TRANSGRID REVENUE RESET APPENDICES

An independent review

Document Reference: AER_TG2009Reset_Appendices_v4_0.doc

Figure E-1 – Flows required on DirectLink to eliminate constraints

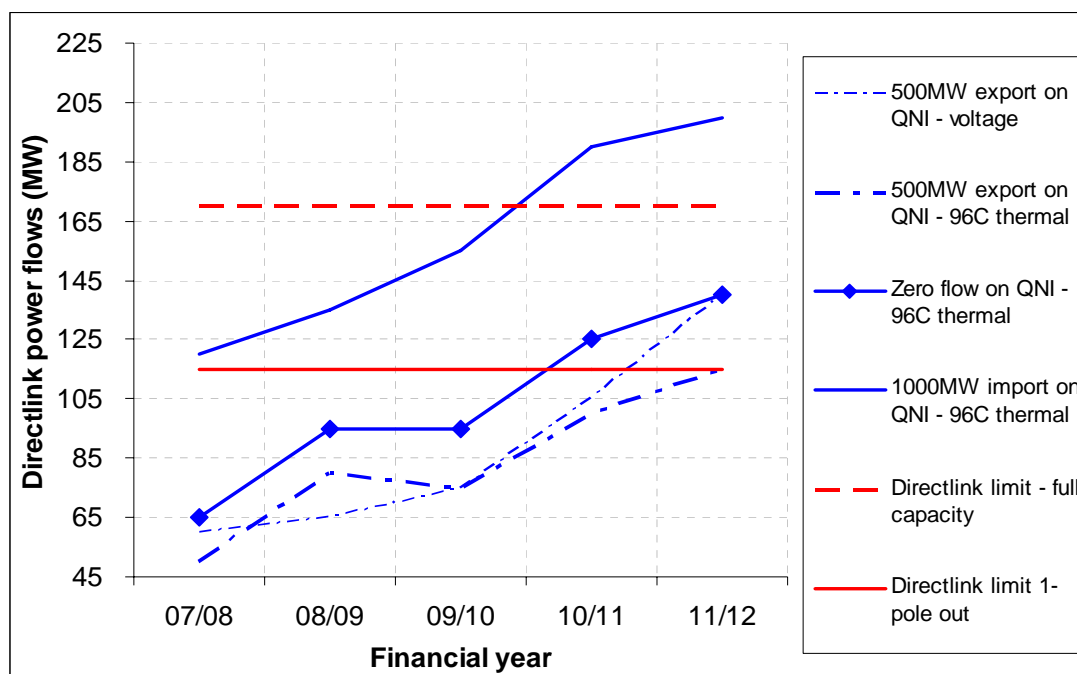
The key observations from Figure E-1 are that:

Figure L-1 – TransGrid average circuit breaker age

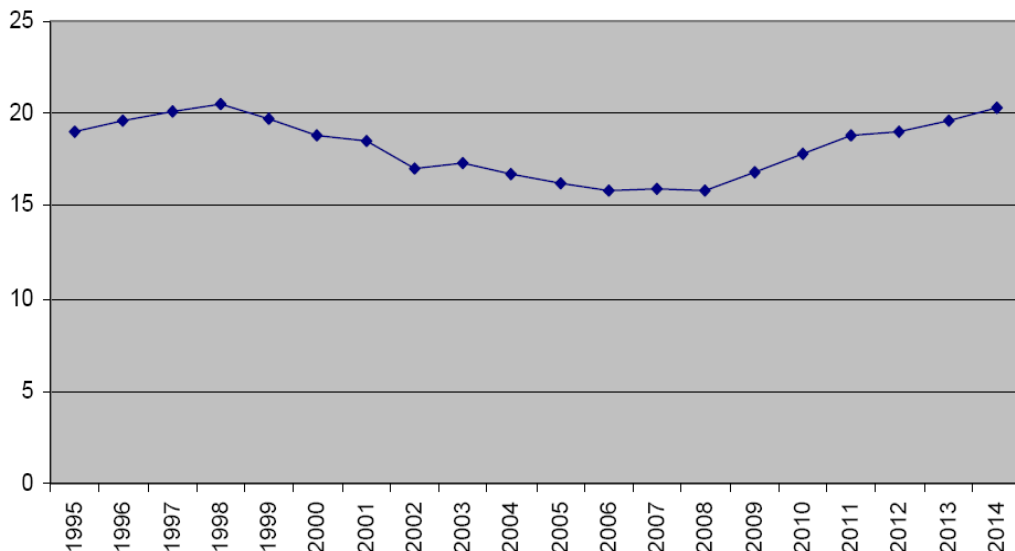
PB note that 23 circuit breaker replacements result from SF6 leakage faults associated with the Merlin Gerin FA1 and FA2 type circuit breakers which will be replaced prematurely.

The effect on the age profile of the circuit breaker replacement programs on the average age of the TransGrid population is shown in Figure E-1. We note that the increase in average age over the period is due to the aging of the large population of circuit breakers installed between 1975 and 1984.

Figure L-2 – TransGrid average transformer age

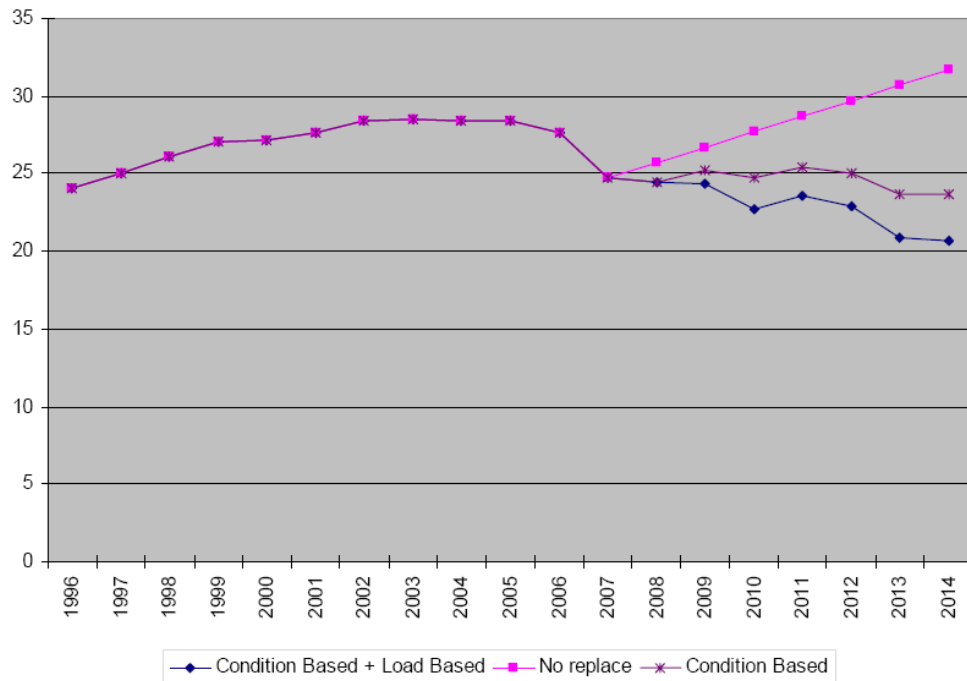
PB note that the majority of TransGrid's transformer replacements are undertaken on a project basis with the need determined by condition monitoring or load growth. A total of 16 additional transformers²⁸⁷, or 9.5% of the TransGrid transformer population, are required for planned condition based replacement projects over the 2009/14 regulatory period. The effect of the proposed replacements on the average age of the TransGrid transformer population is shown in Figure L-2.

Figure L-3 – TransGrid average transmission structure age

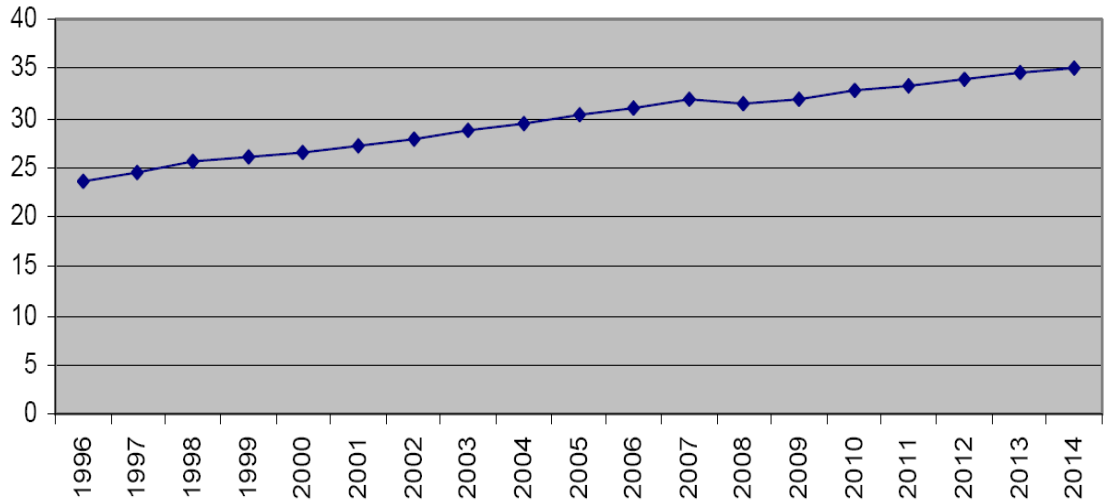
identified significantly reduced asset lives achieved in practice for composite and PI type wood poles. This is consistent with the increased level of replacement when compared to the 65 year standard life.

The effect of the proposed replacements on the average age of the TransGrid transmission line structure population is shown in Figure L-3 and Figure L-4.
